Access Compliance Report

Public Rights-of-Way

| Intersection ID: 13061 | Main Street: LARCH_ST | Cross Street: MERRIMAN_AV | Location: E |
| ADA ID: 0AF21372DC94 | Ramp Type: PerpDiag | Initial Pass/Fail: Fail | Overall Compliance: No |

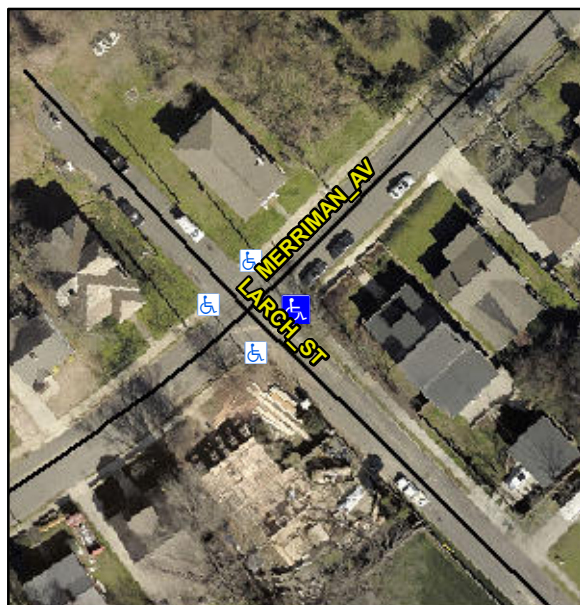
Not Found, R304.5.1, R304.5.3

| Compliance | Description | Data | Compliance | Description | Data |
|------------|-----------------------|-------|------------|-----------------------------|-------|
| N/A | Ramp Length (in) | 80.0 | Yes | Ramp Slope (%) | 5.4 |
| No | Ramp Width (in) | 45.0 | No | Ramp XSlope (%) | 2.5 |

Remove & Replace Curb Ramp With Two New Directional Ramps or Equivalent.
